# UNITED STATES PATENT AND TRADEMARK OFFICE

10/711,842

<b>Office Action Summary</b>	<b>Application No.</b> 10/711,842	<b>Applicant(s)</b> REITER, MARKUS	
	<b>Examiner</b> THOMAS W. IRVIN	<b>Art Unit</b> 3657

## DETAILED ACTION

FIG. 12

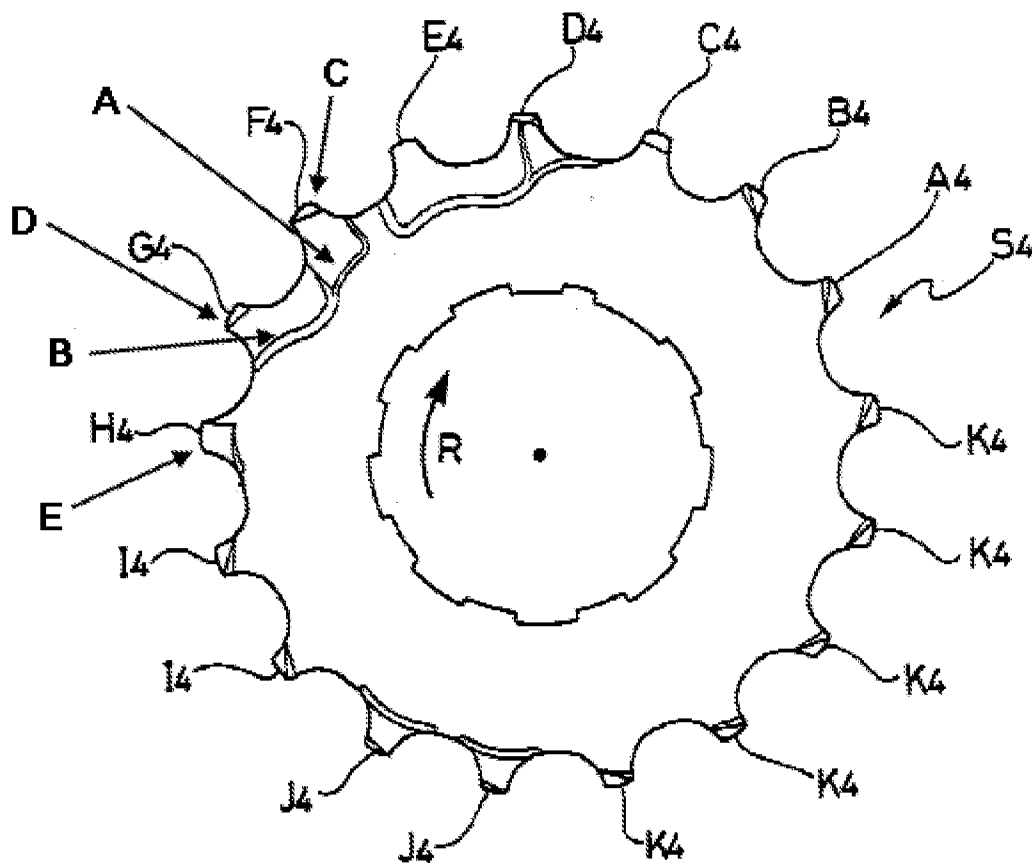
In Re claim 1, with reference to Fig. 3, 13, 14, and 12 (above), Kamada discloses a chainwheel assembly including a plurality of chainwheels (s1-s7) engageable with a chain (23) having successive alternating pairs of inner link plates and outer link plates connected by pins, the pins surrounded by rollers, the chainwheel assembly comprising: at least one smaller chainwheel (s3) having a plurality of teeth spaced about its circumference; and at least one larger chainwheel (s4) having a greater number of teeth spaced about its circumference than the smaller chainwheel, the larger chainwheel and the smaller chainwheel oriented relative to each other such that a distance between a center of the chain roller positioned between a pair of adjacent teeth on the larger chainwheel and the center of the chain roller between a pair adjacent teeth on the smaller chainwheel is substantially an integer multiple of the chain pitch, at least a first tooth (f4) of the pair of adjacent teeth (F4,G4) on the larger chainwheel includes a first lateral recess (A) having a first run-on ramp (see fig. 14), at least a second tooth (G4) of the pair of adjacent teeth disposed adjacent to the first tooth opposite the drive rotation direction including a second lateral recess (B) with a run-on ramp (see fig. 14).

In Re claims 8, 9, and 12, see deflection chamfers (C,D) on the first and second tooth (F4,G4) in fig. 12 above.

**FIG. 5**

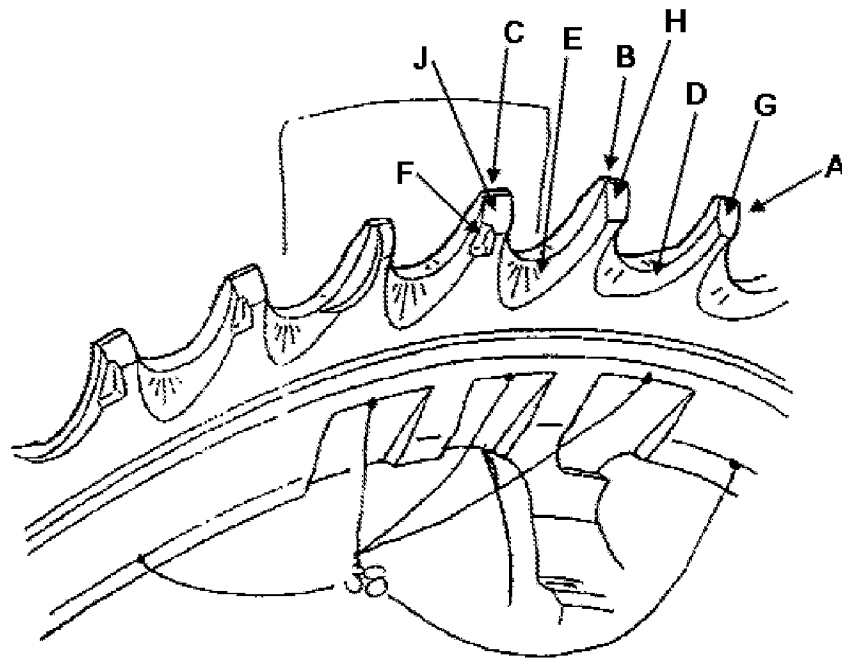
In Re claim 1, with reference to Fig. 5, above, Yahata discloses a chainwheel assembly including a plurality of chainwheels (see fig. 15) engageable with a chain (10), the chainwheel assembly comprising: at least one smaller chainwheel (50) having a plurality of teeth spaced about its circumference; and at least one larger chainwheel (40) having a greater number of teeth spaced about its circumference than the smaller chainwheel, at least a first tooth (A) of a pair of adjacent teeth (A,B,C) on the larger chainwheel includes a first lateral recess and run-on ramp (D), at least a second tooth (B) of the pair of adjacent teeth disposed adjacent to the first tooth opposite the drive rotation direction including a second lateral recess and run-on ramp (E).

In Re claims 2 and 3, see fig. 5.

In Re claim 5, see third tooth (C) which includes a run-out chamfer (F).

In Re claim 7, see fig. 5.

In Re claims 8 and 12, see deflection chamfers (G,H) on the first and second tooth (A,B) in fig. 5 above.
